Notice of Modification

Section 4.55(2) of the *Environmental Planning and Assessment Act 1979*

The development consent (SSD 5850) for the Mount Owen Continued Operations Project, granted by the Planning Assessment Commission, as delegate of the Minister for Planning, on 3 November 2016.

Figure 2A: Development Layout – Mount Owen Continued Operations Project

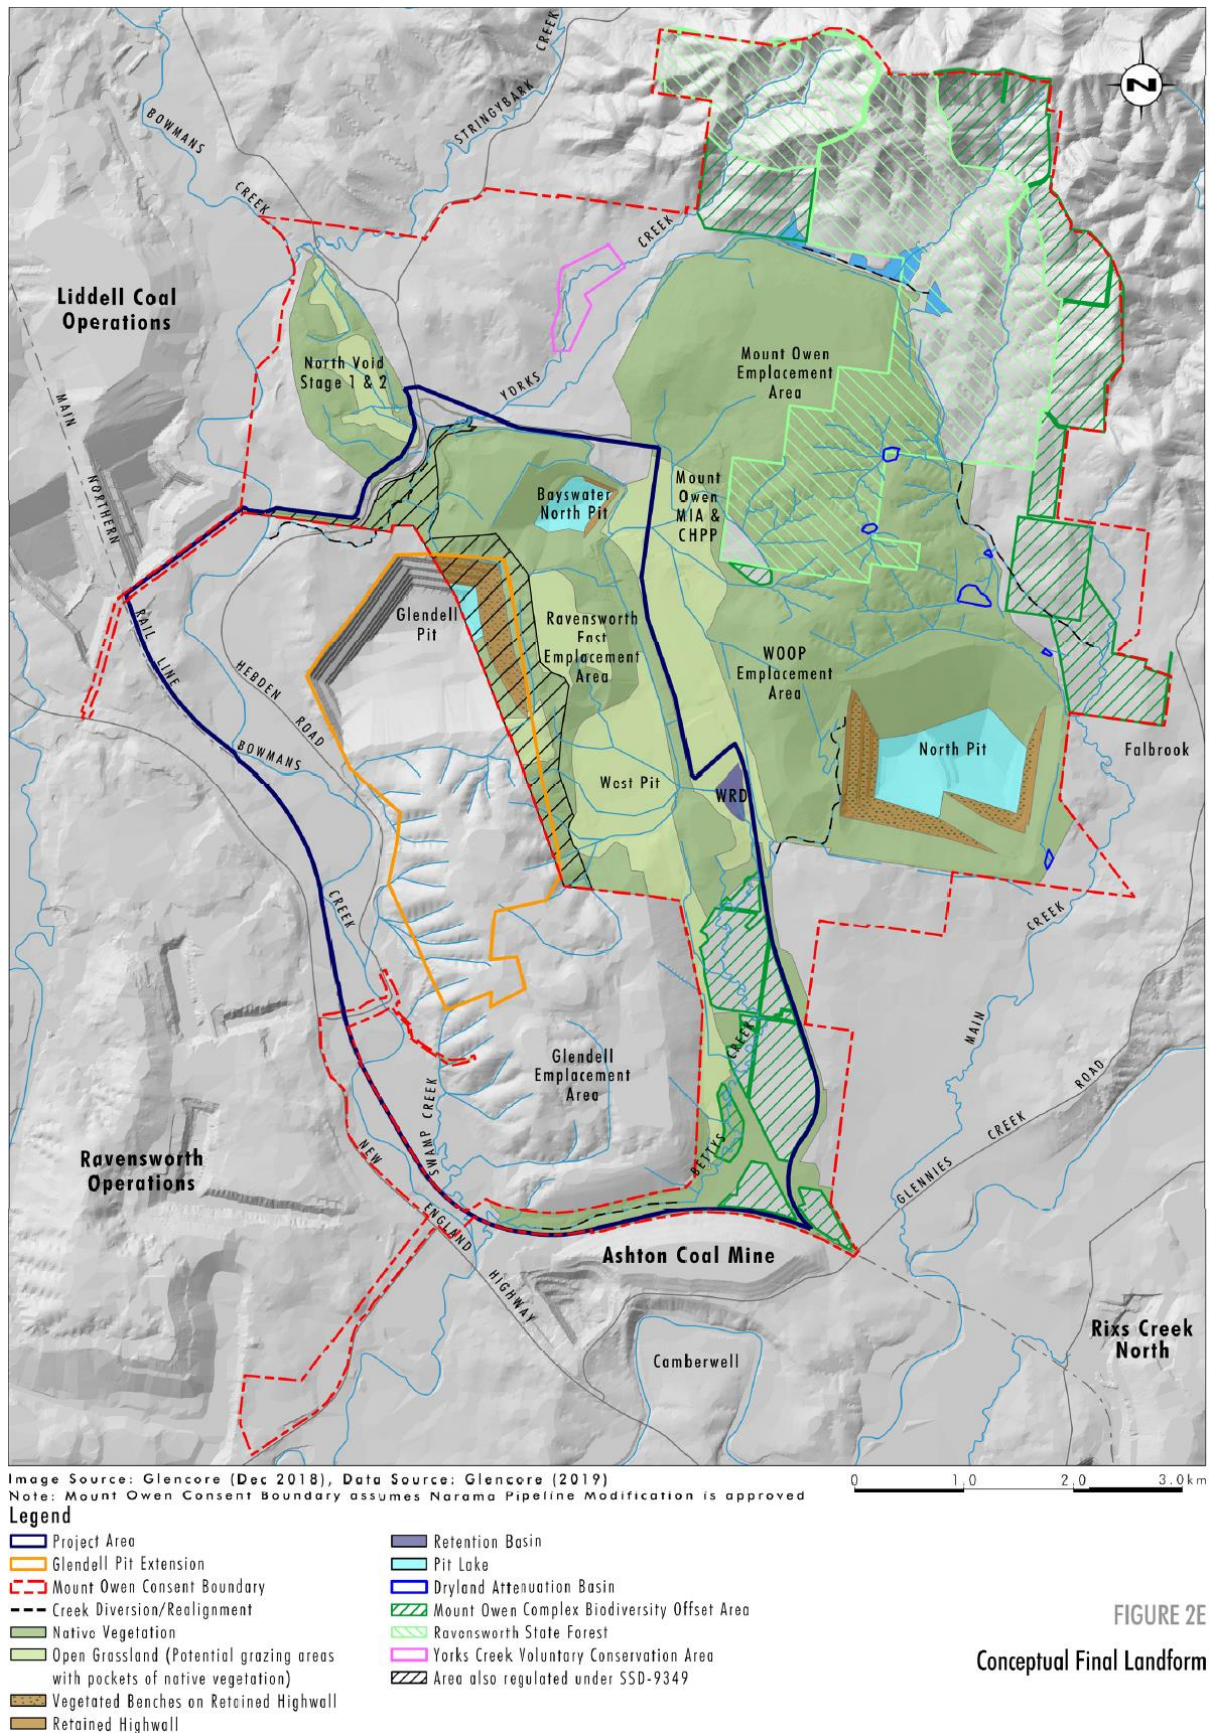
7. In condition 45(a) of Schedule 3, following the words “submitted to the Resources Regulator” delete the words “for approval”.
8. In condition 45 of Schedule 3, delete the words “The Applicant must implement the Rehabilitation Management Plan as approved to the satisfaction of Resources Regulator.”.
9. In condition 46 of Schedule 3, delete the words “2032” and insert “2045”.
10. In conditions 9 and 9A of Schedule 5, delete the words “to compliance@planning.nsw.gov.au” and insert “via the Department’s Major Projects Website”.
11. In Appendix 2, delete Figures 2A and 2E including their descriptions, and insert the following:

Figure 7A: Final Landform Rehabilitation Plan

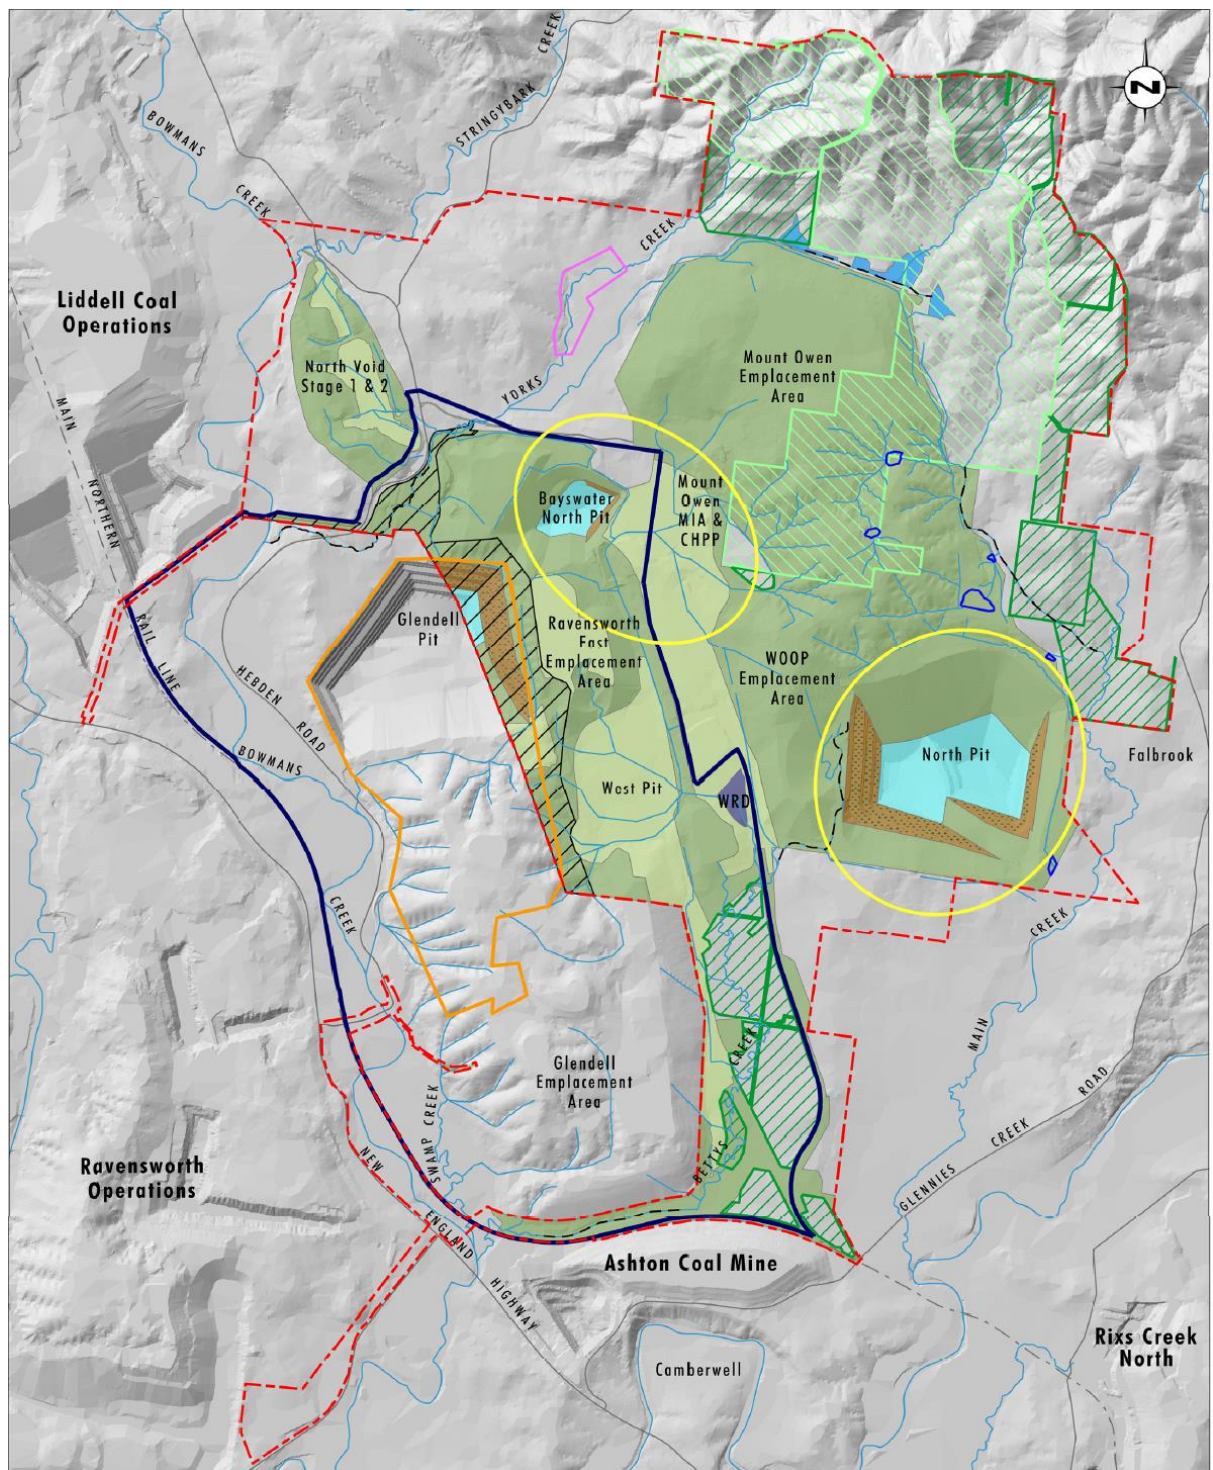
12. In Appendix 7, delete Figures 7A and 7B, including their descriptions, and insert the following:
